APPLICATION NO.	FILING DATE	FIRST NAMED INVENTOR	ATTORNEY DOCKET NO.	CONFIRMATION NO.
10/588,402	08/03/2006	Gunther Flattinger	FLATTINGER ET AL - 1 PCT	6943
25889	7590	11/24/2010	EXAMINER	
COLLARD & ROE, P.C. 1077 NORTHERN BOULEVARD ROSLYN, NY 11576			JENNISON, BRIAN W	
			ART UNIT	PAPER NUMBER
			3742	
			MAIL DATE	DELIVERY MODE
			11/24/2010	PAPER

Office Action Summary	Application No. 10/588,402	Applicant(s) FLATTINGER ET AL.	
	Examiner BRIAN JENNISON	Art Unit 3742

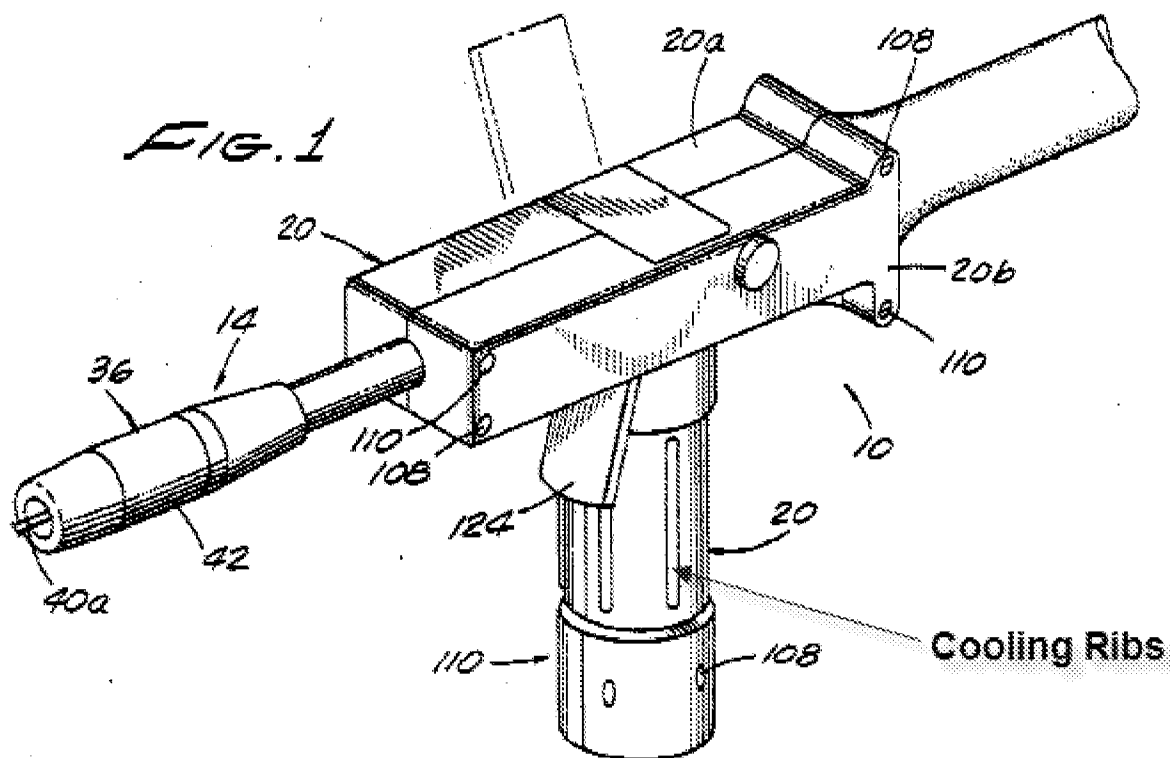
In response to applicant's argument on page 3 of the reply regarding Kensrue not teaching the part of the torch housing being the stator housing, the figure below clearly shows two parts of the housing, which are not required to be separate, that make up a welding torch housing with part of the housing being a stator housing. There are no limitations as to what constitutes a stator housing, it could be any part of the torch housing such as the right rear corner. The phrase "a part of the torch housing represents the stator housing of the drive motor..." is merely an arbitrary phrase describing an unspecified part of the torch.
